CONNECTICUT YANKEE ATOMIC POWER COMPANY

HADDAM NECK PLANT

Haddam Neck Station
Response to
Request for Additional Information On Isolated Loops

Request for Additional Information On Isolated Loops

Figure 1: Pressure-Temperature Limit Curves for Isolated Loop: Haddam Neck

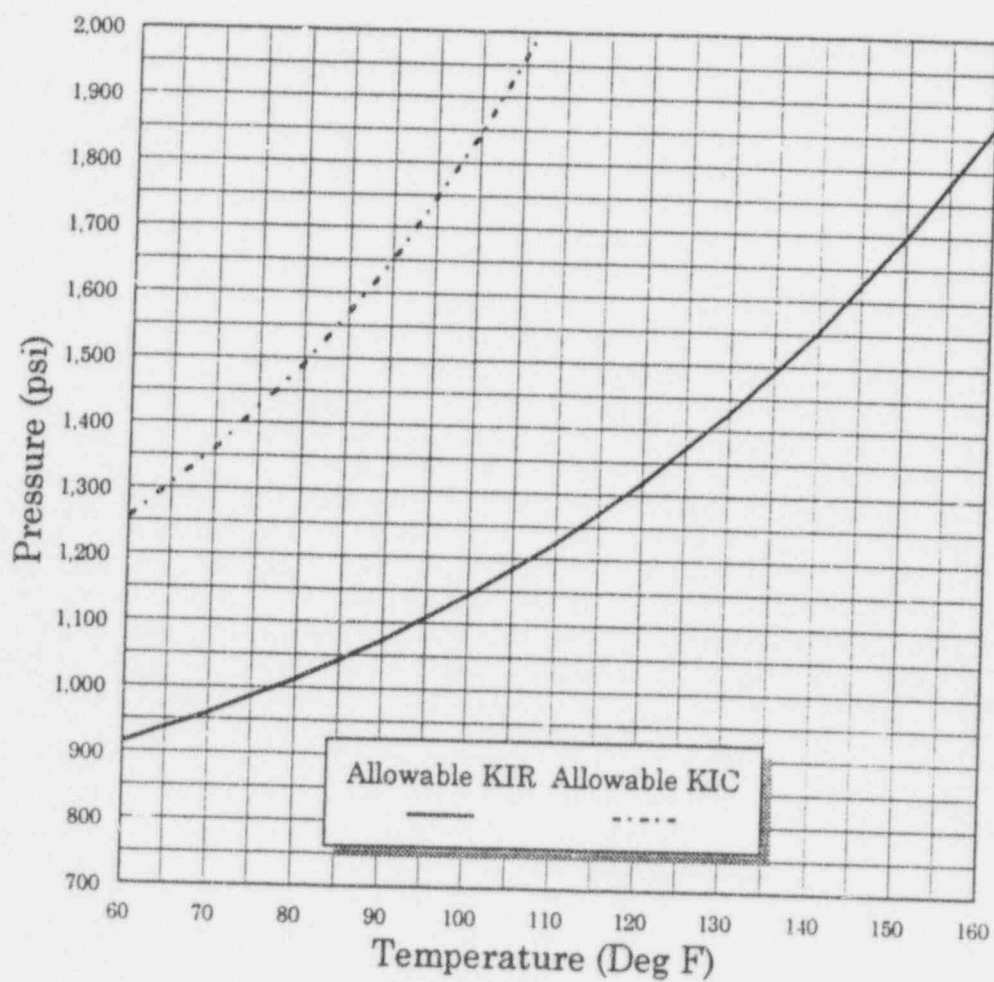
Demonstrate that the calculations performed to analyze the July 1994 event by the methods of ASME Section III (or Section XI) Appendix G are correct. Provide additional detail on the geometry of steam generator channel head including head diameters and wall thicknesses, the results of the channel head stress analysis, the assumed flaw orientation and size, the material properties for the ferritic materials in the channel head, and the loading conditions (pressure and temperature) during the July 1994 event. This information will permit the staff to independently assess the significance of the event.

The calculations performed to analyze the July 1994 event were performed by Westinghouse in accordance with the methodology described in Appendix G of the ASME, Section III Code. A summary description of the results of this calculation is provided in Attachment 2 (letter from D. E. Prager, Westinghouse, to N. F. Azevedo). The calculations were reviewed and accepted by the CYAPCO Engineering Staff.

toughness. The curve of allowable pressure as a function of temperature is given in Figure 1. Also contained in this figure is another pressure temperature curve based on a more realistic assessment of the fracture toughness, the K_{IC} curve of the ASME Code Section XI. This more realistic curve is presented in the figure as a dashed line, and shows that a margin of at least 40% exists for the curve to be used for the isolated loop.
